## SERVICE TECHNICAL INFORMATION

### ONE POINT REPAIR

REF. NO. : SI-96-018

MODEL : NSX-V800. CX-NK80. NAV80

Fig. 1

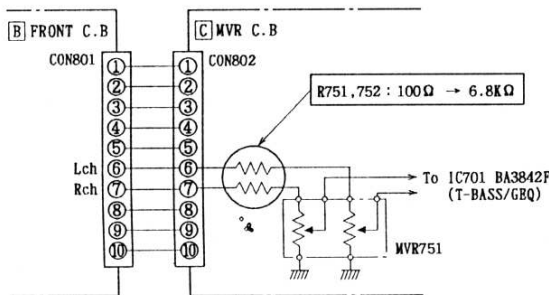
CONTENTS : While playing the CD with T-BASS ON, BBE ON, GEQ ON (Rock or Disco), and with the volume beyond the 10 o'clock position, errors such as CD dropout or movement of the SP BOX occur.

Ref.		Parts No,	REMARK
R751, 752	C-RES, 100 $\Omega$ -1/10W	$\rightarrow$ C-RES, 6.8K $\Omega$ -1/10W	Fig-1
C221, 222	CAP, 1 $\mu$ /50V	$\rightarrow$ CAP, 0.1 $\mu$ /50V	Fig-2
C229, 230	CAP, 10 $\mu$ /50V	$\rightarrow$ CAP, 2.2 $\mu$ /50V	Fig-2
